**Project: IEEE P802.15 Working Group for Wireless Personal Area Networks
(WPANs)**

Submission Title: comment resolution assignment

Abstract: proposes comment resolutions for a set of CIDs

Figure 23: Two Part Preamble

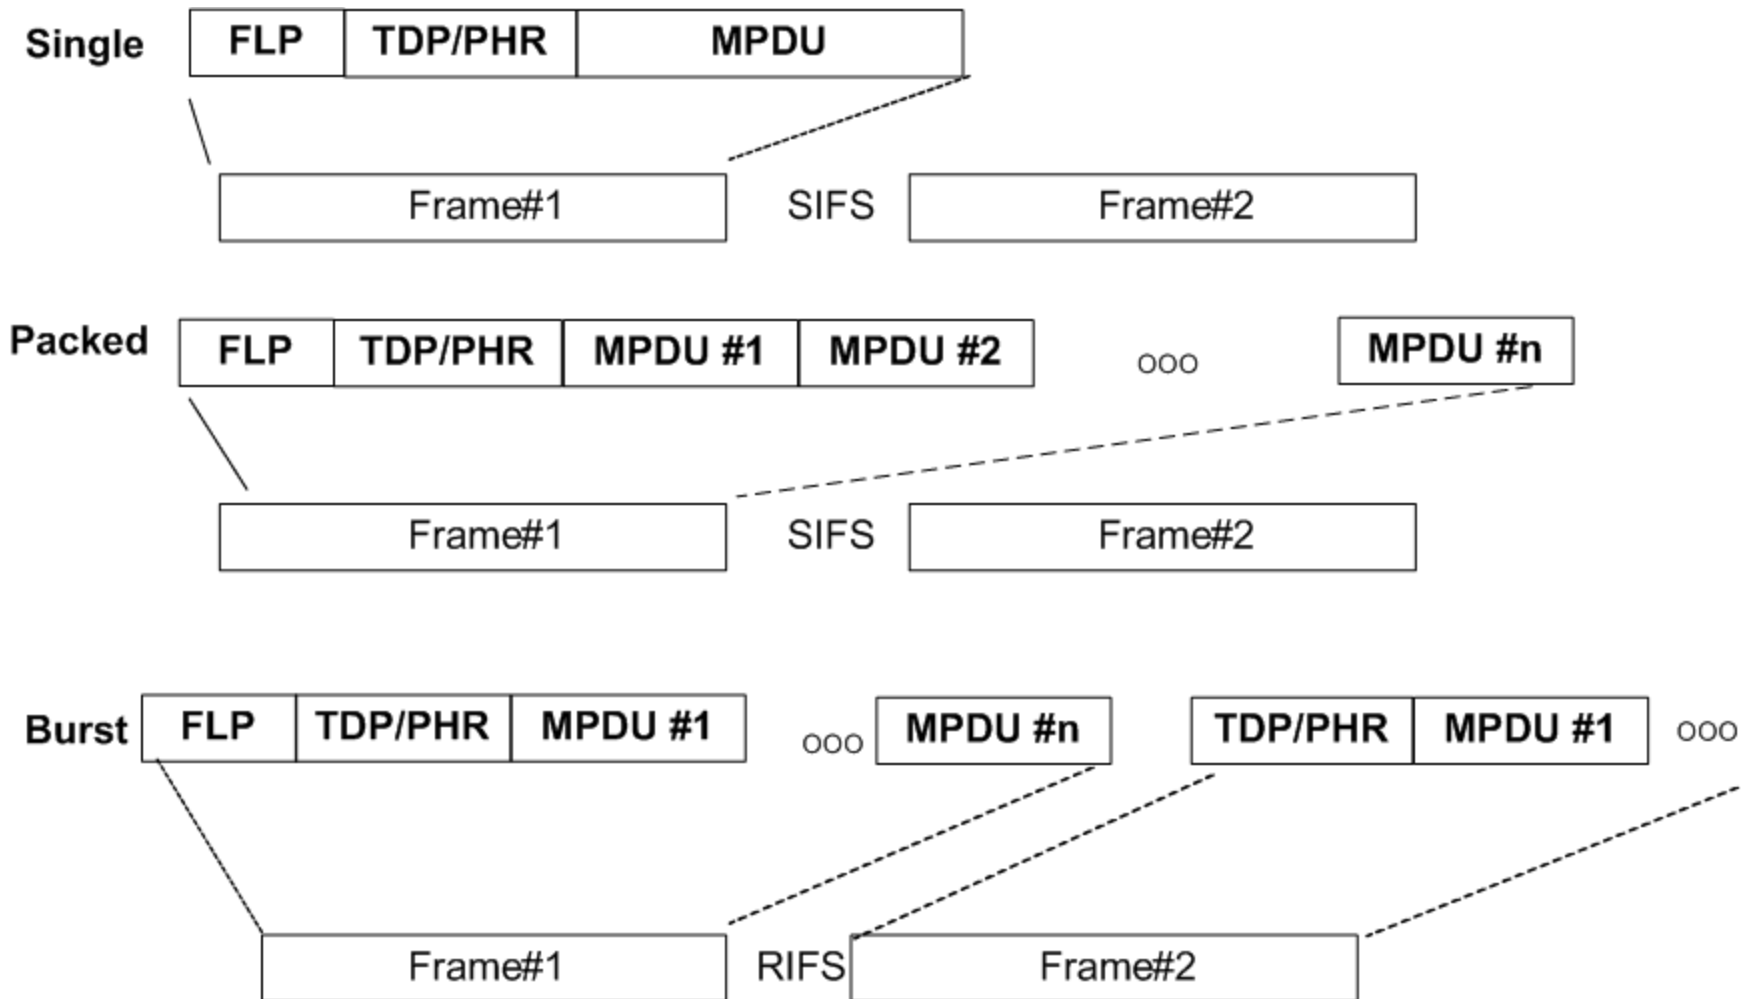
- In Figure 20, in Burst mode, there are two MAC PDU #n. These should be fixed.
- Figure 20 - Burst Mode - shows the same MAC PDU being transmitted twice, in both Frame #1 and #2. This figure does not align with the text
- (SY) In Burst mode, both packets are shown with the label "MAC PDU #n". I believe that the labels should be different

- Redraw the figure with correct PDU numbers.
- replace first MAC PDU #n with MAC PDU #1 and second MAC PDU #n with MAC PDU #2

Instruction to editor: Update Figure 23

Update Page 39, line 40 as follows:

- The standard defines one fast locking pattern (FLP) followed by choice of 4 topology dependent preamble (TDP) repetitions for the purposes of distinguishing different PHY topologies.

Update Page 39, line 46 as follows:

- After the fast locking pattern, 4 repetitions of one of four TDPs are sent.

Define Preamble composed of two parts: FLP – Fast Locking Pattern, TDP – Topology Dependent Pattern

Page 38, line 33. Add “The FLP shall be dropped in the burst mode.”
